ARC REVIEW CODE: R2109201

TO: Mayor Troy Brumbalow, City of Cumming
ATTN TO: Scott Morgan, Director of Planning and Zoning
FROM: Douglas R. Hooker, Executive Director, ARC
RE: Development of Regional Impact (DRI) Review

Name of Proposal: Sawnee Village DRI #3395

DRI SITE PLAN

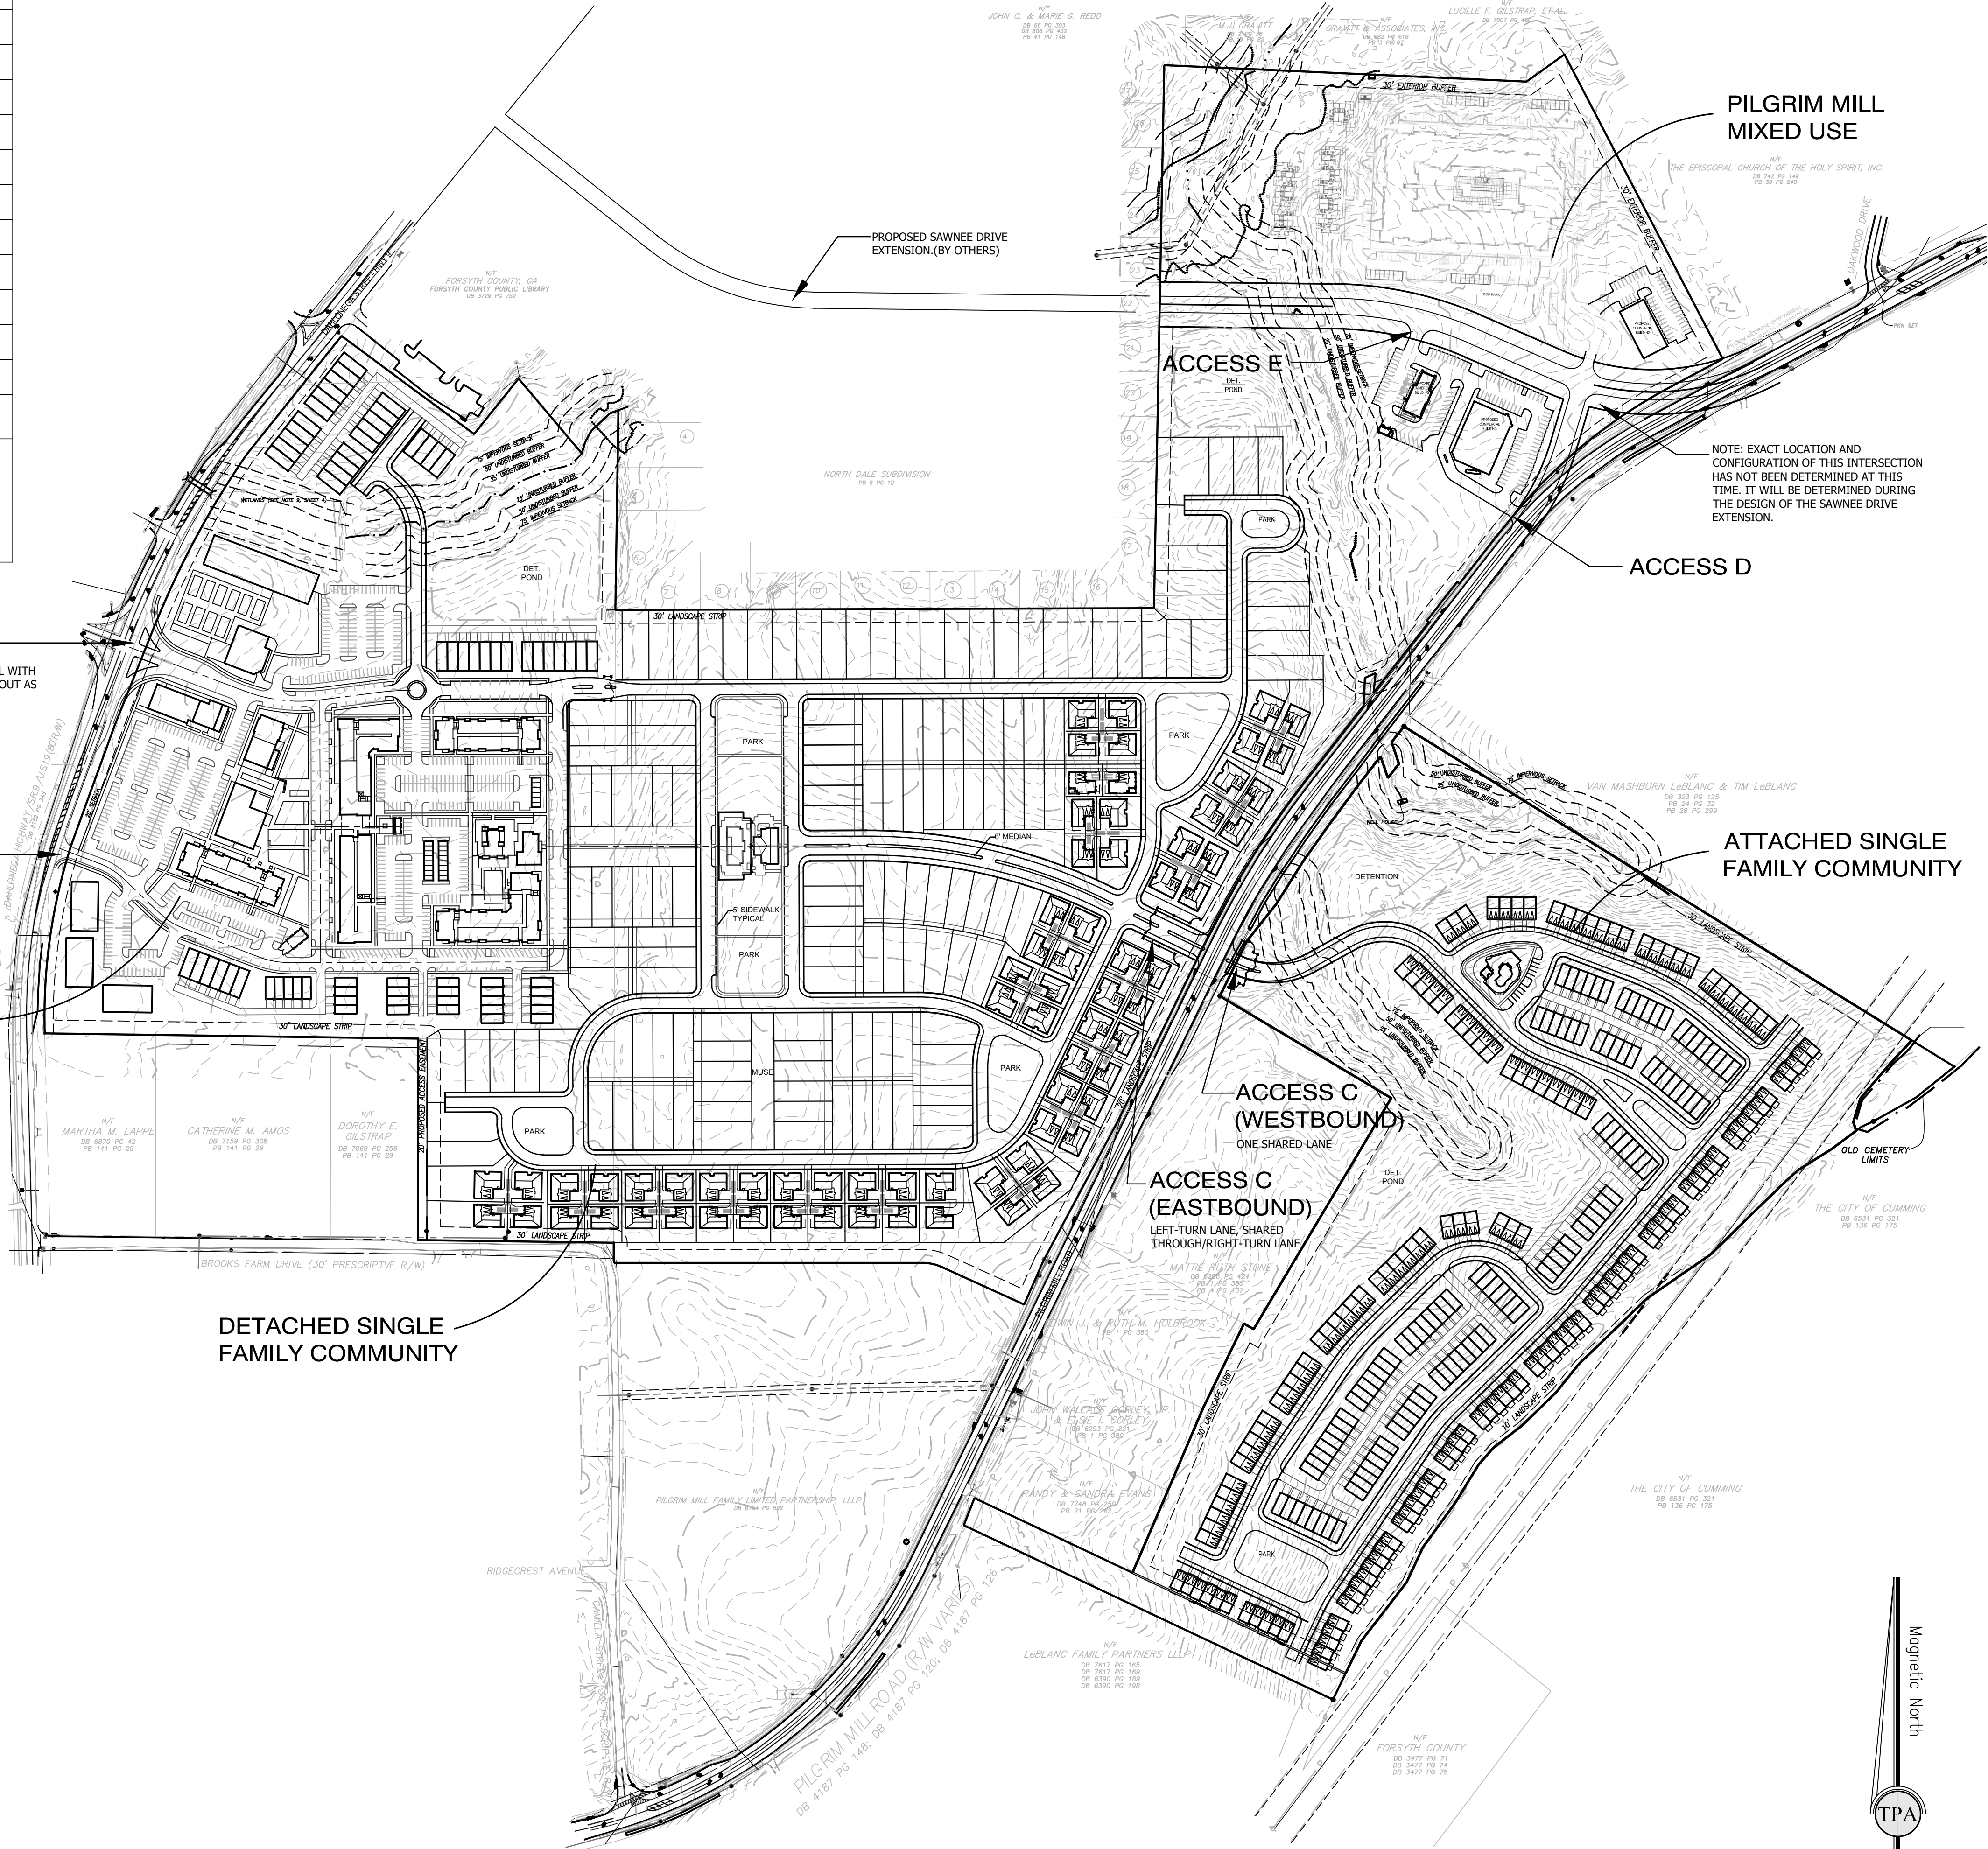
To capitalize on the DRI's potential, care should be taken to ensure that the development, as constructed, promotes an interconnected, functional, clearly marked and comfortable pedestrian experience on all streets, paths, entrances, and parking areas. ARC also recommends the installation of sidewalks along all site frontages (Dahlonaga Street/SR 9, Sawnee Drive Extension, and Pilgrim Mill Road). To the maximum extent possible, new driveways and intersection corners where pedestrians will cross should be constructed with minimal curb radii to reduce speeds of turning vehicles and decrease crossing distances for pedestrians.

Special consideration should be given to bike and pedestrian facilities that safely accommodate users navigating the commercial/retail section of the project on the west side of the site – as well as crosswalks to allow safe access across Dahlonaga Street (SR 9) to Otwell Middle School and Cumming Elementary School. One logical location for crosswalk infrastructure is at Site Driveway A, but crosswalks are not identified on the DRI site plan. As part of the GRTA-required traffic impact study and per GDOT policy, an Intersection Control Evaluation (ICE) was performed at this intersection. Subject to GDOT approval as part of the driveway permitting process, the traffic study indicates that a traffic signal (with turn lanes), if warranted, or a single-lane roundabout (with northbound and southbound right-turn slip lanes), may be considered for future intersection control. It is important to note that there is also a long-range SR 9 widening project (GDOT PI #141890) that will include this segment of the roadway. The traffic study recommends considering the widening project when identifying future intersection control alternatives. Ultimately, the widening and the chosen intersection control method and design of SR 9 at Site Driveway A will need to accommodate clear, safe, convenient bike/pedestrian crossing facilities.

The site plan appears to indicate that all streams on the property will be adequately buffered. Specifically, the plan shows a stream with a short tributary on the eastern portion of the project property and a stream on the western side of the property. All indicated streams show the 25-foot State Sediment and Erosion Control buffer as well as the City of Cumming Stream Buffer Ordinance's 50-foot stream buffer and 75-foot impervious setback. The only proposed development crossing the buffers are two road crossings, which may require variances. These and other comments on water resources from ARC's Natural Resources Group are attached.

One final item of note is the submitted DRI traffic impact study indicates that the senior living residential component of this DRI is proposed for an area north of Sawnee Drive Extension and will be served by Site Driveway E. However, on the submitted DRI site plan, that area is shown as “Pilgrim Mill Mixed-Use” and building footprints are greyed-out. As the City review process moves forward, the applicant team should make clear the proposed use and configuration for this area of the site.

The USGS coverage for the project area shows no blue line streams in or near the property. The submitted site plan shows a stream with a short tributary on the eastern portion of the project property and a stream on the western side of the property. All indicated streams show the 25-foot State Sediment and Erosion Control buffer as well as the City of Cumming Stream Buffer Ordinance's 50-foot stream buffer and 75-foot impervious setback. The only proposed development crossing the buffers are two road crossings, which may require variances. Any unmapped streams on the property may also be subject to the City stream buffer ordinance, and all waters of the state on the property are subject to the State 25-foot Sediment and Erosion Control buffer.

- ☐ YES (*connections to adjacent parcels are planned as part of the development*)
- ☐ YES (*stub outs will make future connections possible when adjacent parcels redevelop*)
- ☒ NO (*the site plan precludes future connections with adjacent parcels when they redevelop*)
- ☐ OTHER (*Please explain*)
